City of El Paso – City Plan Commission Staff Report

Case No:	SUSU15-00060 Tierra del Este Unit 68, Replat A
Application Type:	Resubdivision Combination
CPC Hearing Date:	October 22, 2015
Staff Planner:	Joaquin Rodriguez, (915) 212-1608 rodriguezjx3@elpasotexas.gov
Location:	South of Montwood and East of Rich Beem
Acreage:	.83 acres
Rep District:	5
Existing Use:	Vacant
Existing Zoning:	C-2 (Commercial)
Proposed Zoning:	C-2 (Commercial)
Nearest Park:	Tierra del Este 68 Park (.33 Miles)
Nearest School:	Pebble Hills Highschool (1.2 Miles)
Park Fees Required:	N/A
Impact Fee Area:	Eastside
Property Owner:	Ranchos Real XV, LLC
Applicant:	Ranchos Real XV, LLC
Representative:	Conde Inc.

ATTACHMENT 4

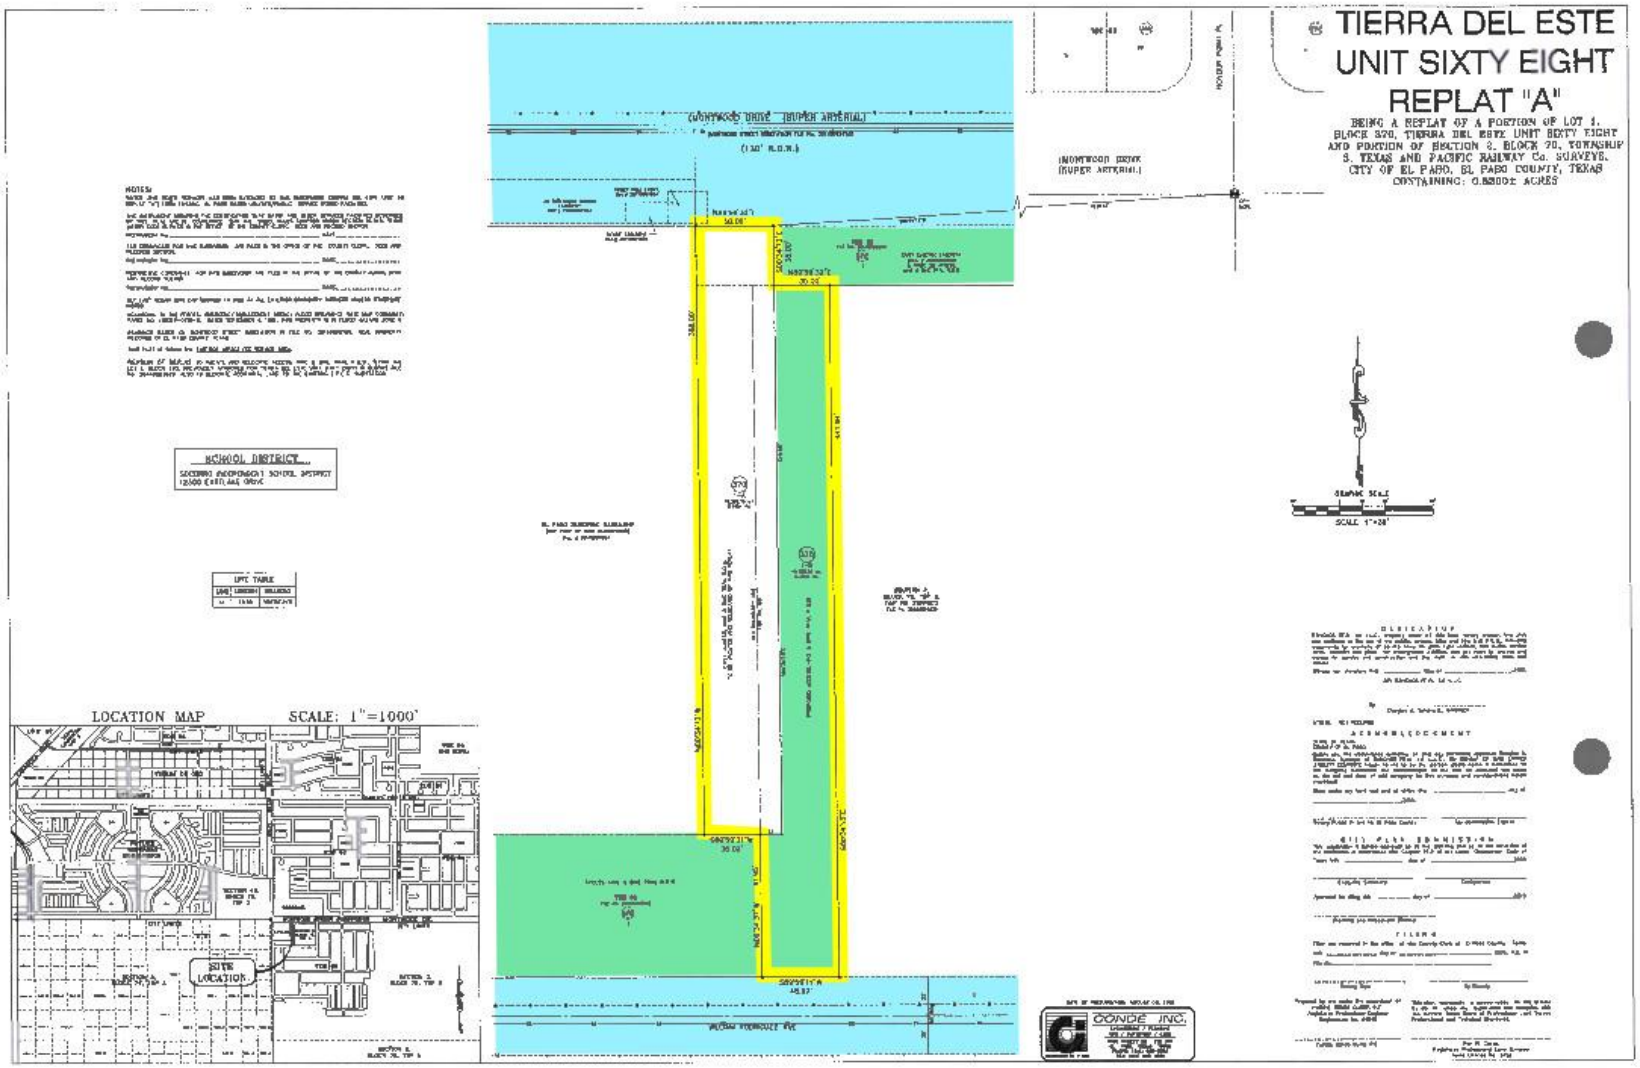
- The engineer will include the Eastside Service Area Impact Fee Table on the face of the final plat.
